Site/Project Location: Brady Wind Energy Center – Stark County **Date of Inspection:** 26 September 2016

159 PU-15-690 Filed 10/04/2016 Pages: 3
Site inspection trip report - Construction Inspection Report September 26, 2016
Keitu Engineers & Consultants, Inc.

Report Photo #1 "Topsoil Mixing In Subsoil Pile From Previous Inspection"

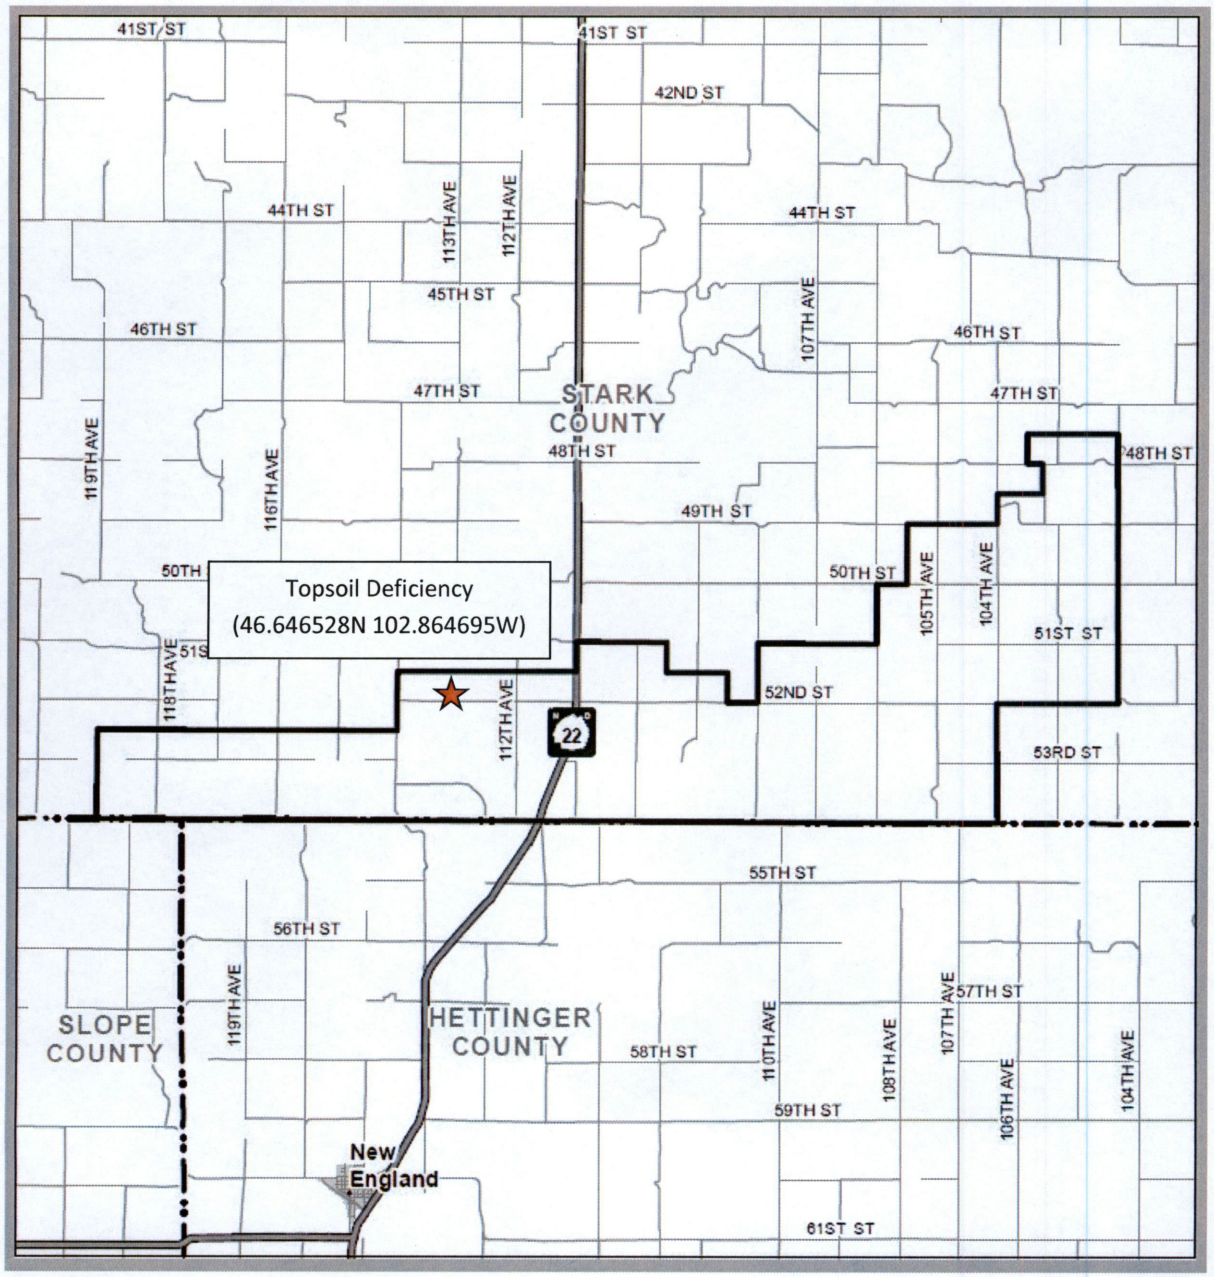
At the time of this inspection there are no new topsoil management issues. However, top soil management issue from previous inspection has not been resolved. The construction crew have shown to be doing an adequate job reclaiming disturbed areas. Turning radius improvements have been implemented on multiple locations. Crew was informed to be cautious during cleanup of gravel in road ditches as they do not want to impact the soil and the roots of vegetation in those areas. Erosion control has been implemented in disturbance areas and heavy slopes. Weather conditions from the weekend have damaged the silt fence at site 29, Kyle McNab stated the issue will be fixed by the end of the day.

Topsoil mixing in subsoil pile issue from previous construction inspection on 8/16/16 had not been resolved at the time of the inspection (9/26/16).

Blattner Energy crew has been informed to address topsoil management issue. Crew will pull topsoil off of subsoil pile being cautious not to mix during removal. This site will be scheduled for a post-construction inspection check.
